**SUBDIVISION &  
PLANNED UNIT DEVELOPMENT  
STAFF REPORT**

**Date: November 3, 2022**

Zeigler Boulevard Apartments

Subdivision approval to create three (3) legal lots of record from a single metes-and-bounds parcel; and Planned Unit Development approval to allow multiple buildings on a single building site, and shared access between building sites.

# DETAIL SITE PLAN

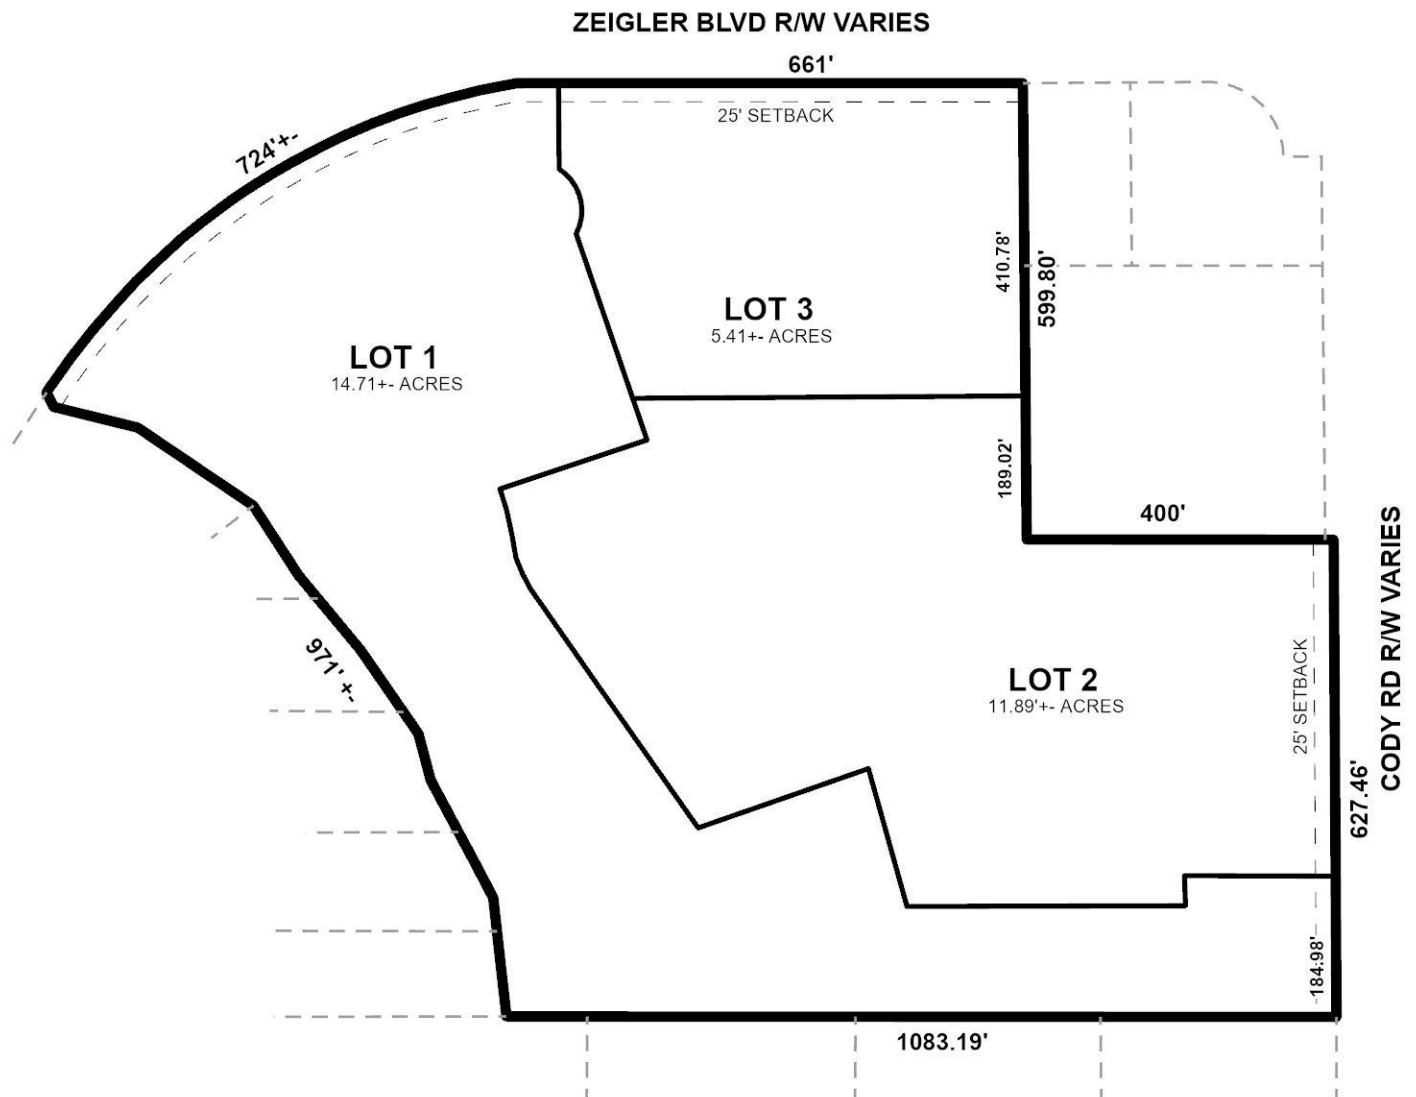
*It should be noted that there are drainage and utility easements depicted on the site plan, that are not on the revised preliminary plat submitted. If approved, the easements should be depicted on both the site plan and Final Plat, as well as a note stating that no structures are allowed in any easement without the permission of the easement holder.*

*The revised PUD plan submitted by the applicant states that there will be three (3) phases, with 264 dwelling units in Phase One, 282 dwelling units in Phase Two, and 186 units in Phase Three, for a total of 732 dwelling units. It should be noted that based on the size of the site, the Zoning Ordinance allows a maximum of 924 dwelling units.*

*In addition to the 732 dwelling units, the site plan shows a gatehouse, a clubhouse with pool, a dog park, two (2) “gather” areas, a play area with barbeque, a central mailbox location, two (2) maintenance buildings, and two (2) trash compactors. Based on the size of all structures on the site and the number of dwelling units, a total of 1,121 parking spaces are required. The site plan submitted depicts a total of 1,123 parking spaces. As stated previously, due to the development having more than 25 parking spaces, a compliant photometric site plan will be required at the time of permitting, if approved.*

*As mentioned, the site plan illustrates two (2) trash compactors on the site, and has a note stating that they will be connected to sanitary sewer and have a compliant enclosure. If approved, this note should be retained on the site plan.*

*As the site has a “gatehouse” at one of the proposed entrances from Zeigler Boulevard, it is assumed that there will be a gate, which is not depicted on the site plan. If a gate is proposed, it should be depicted on the site plan with sufficient queuing spaces (9-feet x 20-feet). If the gate is to be electronic, a note should be placed on the site plan stating such, and a minimum of one (1) queuing space should be provided. If the gate is not to be electronic, a note should be placed on the site plan stating such, and a minimum of three (3) queuing spaces should be provided. All gates should comply with Fire Department regulations regarding access to the site.*

*It should be noted that the site plan depicts the proposed central mailbox location on Phase 2. If approved, this should be relocated to Phase 1, so that all phases are serviced.*

*The site plan submitted depicts the existing sidewalk along Zeigler Boulevard, and a proposed sidewalk along Cody Road North. If approved, the sidewalks should be retained on the site plan, if approved.*

- 3) depict all easements on the site plan, with a note on the site plan stating that no structures are allowed in any easement without the easement holder's permission;

- 4) revision of the site plan to provide a central mailbox location for Phase One;
- 5) retention of the note on the site plan stating that all trash compactors will be connected to sanitary sewer and have a compliant enclosure;

- 6) placement of a note stating that preservation of existing trees will be coordinated with Urban Forestry to insure their continued survival;
- 7) placement of a note on the site plan that new tree plantings will be coordinated with staff at the time of permitting;

- 8) retention of the sidewalks along both street frontages;
- 9) depiction of all gates at entrances, to comply with Fire Department requirements;
- 10) either placement of a note on the site plan stating that the gate is to be electronic, with a minimum of one (1) queuing space (9-feet x 20-feet) provided, or placement of a note on the site plan stating the gate will be manual, with a minimum of three (3) queuing spaces provided;
